City of Santa Barbara  
Planning Division

**Memorandum**

**SUBJECT:** 565 Yankee Farm Road

**PRELIMINARY DRAINAGE REPORT**  
**For the Proposed**  
**HONUAKAI RESIDENCE**  
**565 YANKEE FARM ROAD**  
**APN 047-030-005**  
Santa Barbara, California

**Exhibit 3: Revised Lower Level Floor Plan**  
(Achieves basement credit without changes to grading plans.)

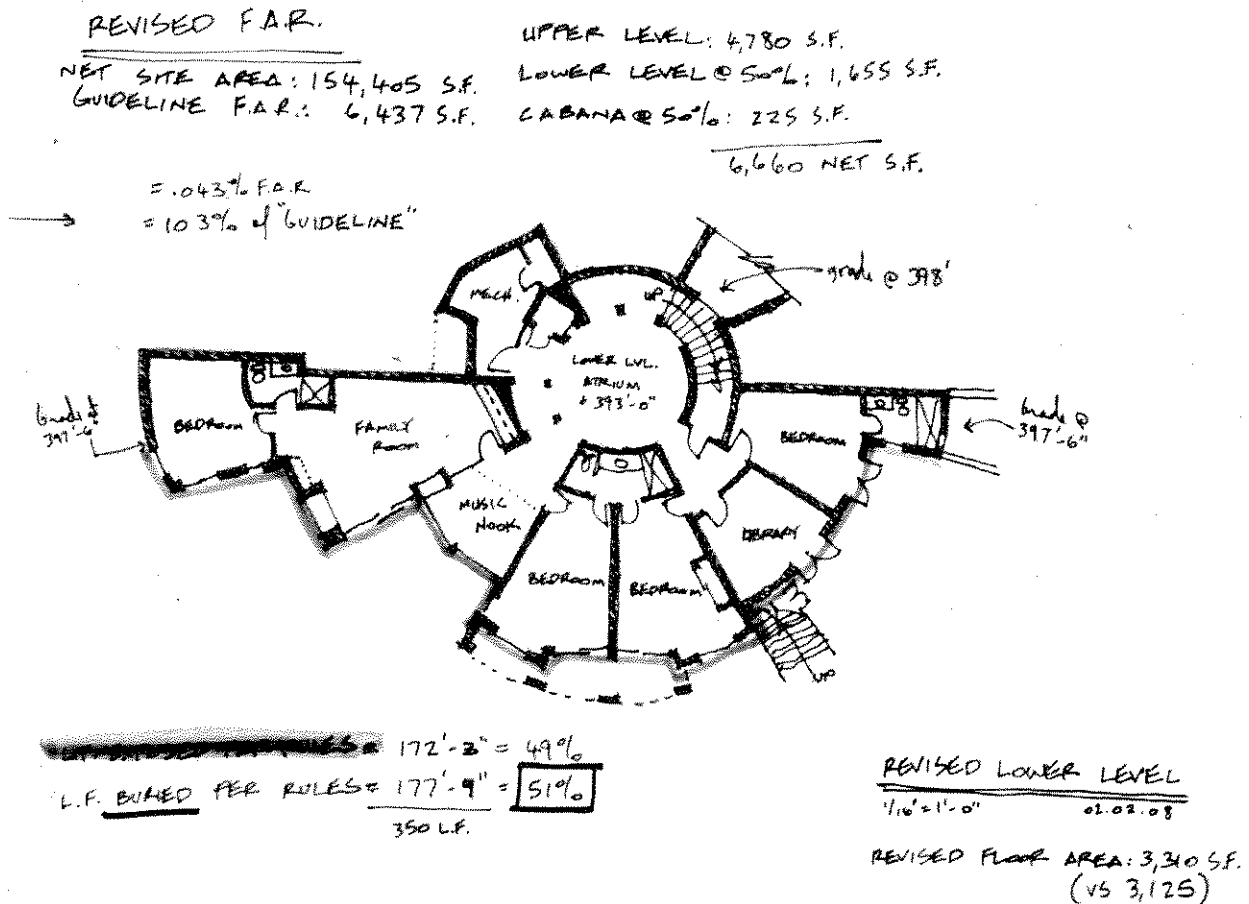
- *Consider reducing the size of the structure and returning to design review for input.*

The applicant has demonstrated that additional fill against the building could reduce the amount of "exposed" walls on the lower floor, thus qualifying for a basement credit. With the basement credit (for both the lower floor and the cabana), the project would be 103% of the recommended FAR. Thus, there have been no significant changes to the structure that would require further conceptual review by the ABR. On the lower floor, one wall was extended from the building, which allows for a roof element to be added from the upper floor. Additionally, the applicant has provided diagrams, which are attached to this memo, to demonstrate that portions of the upper and lower floor walls are offset. By offsetting the walls, the building would not read as one solid two story mass. The applicant will bring a physical model to the Planning Commission meeting to help with visualizing the project.

We also studied the basement credit rule and found it very easy to meet. We were able to achieve the basement credit by slightly reducing the amount of linear length of exposed walls and increase the amount of buried walls. There was no effect to the grading plan or the need for any additional retaining walls to manipulate grades around the perimeter of the structure. The solution ironically increased square footage by 180 sf to achieve compliance with the language of City regulations as adopted, but at the same time reduced the amount of 2 story vertically stacking walls from 8% of the project to a mere 4%. (See Exhibit 3)
